**ADDENDUM NO. 1**  
**FOR**  
**MONTE SANO TRAILHEAD FACILITIES PAVILION WITH**  
**RESTROOMS INCLUDING ACCESSIBLE PARKING**  
**RTP PROJECT NO. 15-RT-54-02**  
**DCNR PROJECT NO. 47-P-55**  
**BC PROJECT NO. 2018397**

**NOVEMBER 16, 2018**

SUBJECT: Plans, Specifications, and Contract Documents are hereby amended, modified, and changed as follows:

**PLATES**  
 SCALE: 3/4" = 1'-0"

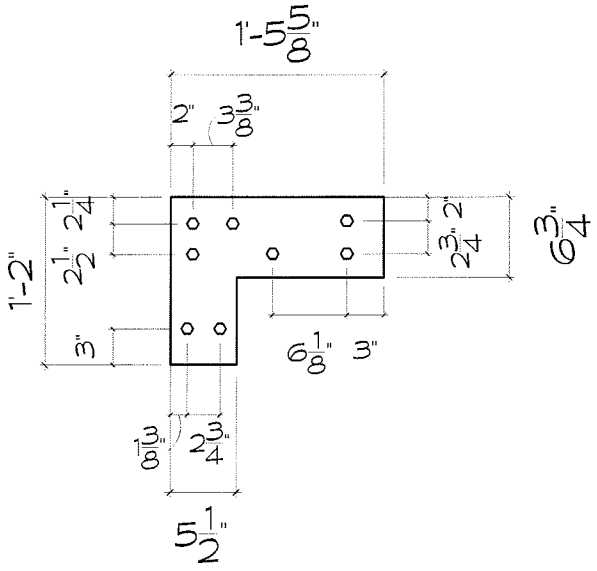
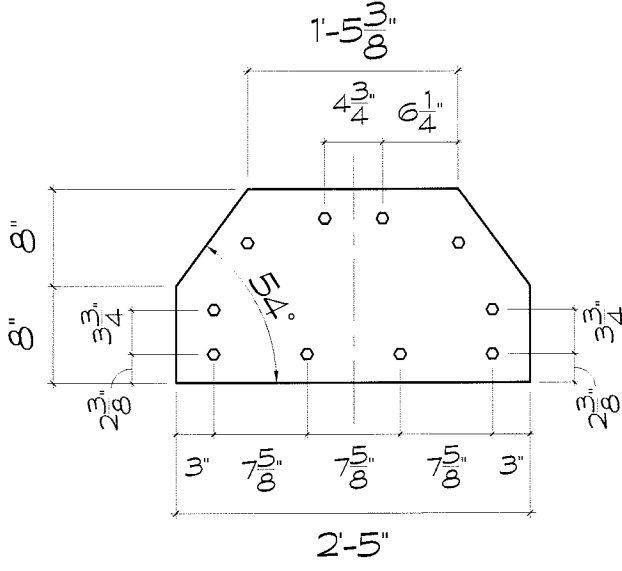
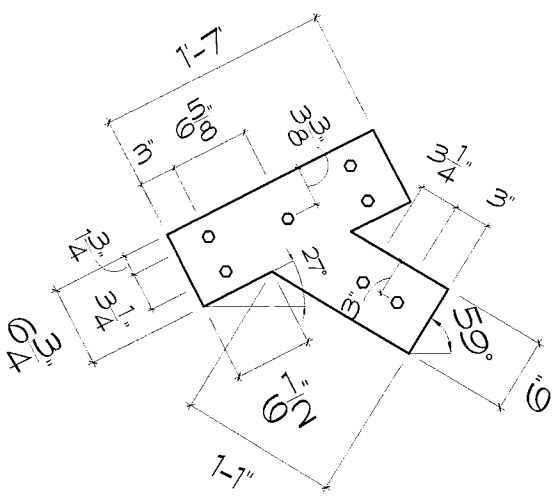
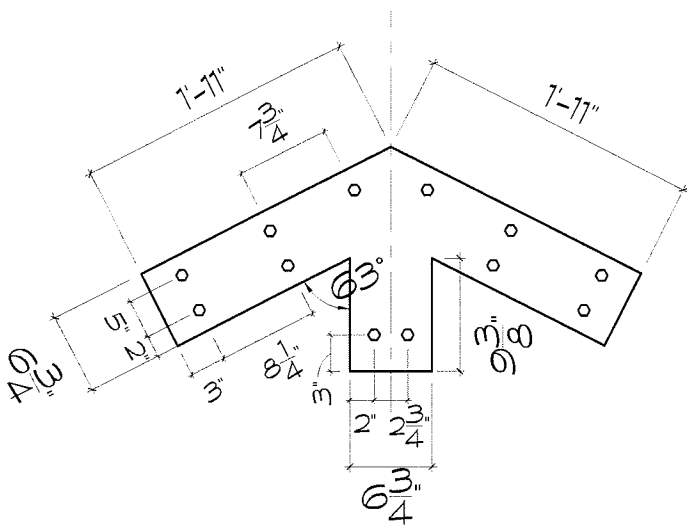
- A. Add the enclosed plate details on page ADM1-3 to Sheet A3.
- B. On Sheet A3, enlarged detail 3/A3, it is the contractor's option for an end wall truss in lieu of building the end wall as shown on detail. The end wall truss will be a standard gable end wall truss that accommodates a louver as shown on detail.
- C. The term "timber" on the drawings does not indicate a specific wood species. Refer to the specifications.
- D. All exposed lumber is to be painted or stained. Color as selected by Architect and Owner.

- D. A question was asked about the plates on the trusses. Refer to paragraph IV above.
- E. A question was asked about payment for rock. There is no additional payment for rock encountered during construction.

1/4" STEEL PLATES POWDER COATED BLACK WITH 1/2" Ø HEXAGON BOLTS WITH NUTS AND WASHERS. VERIFY PLATE WILL COVER GANG NAIL PLATE. ADJUST AS REQUIRED.
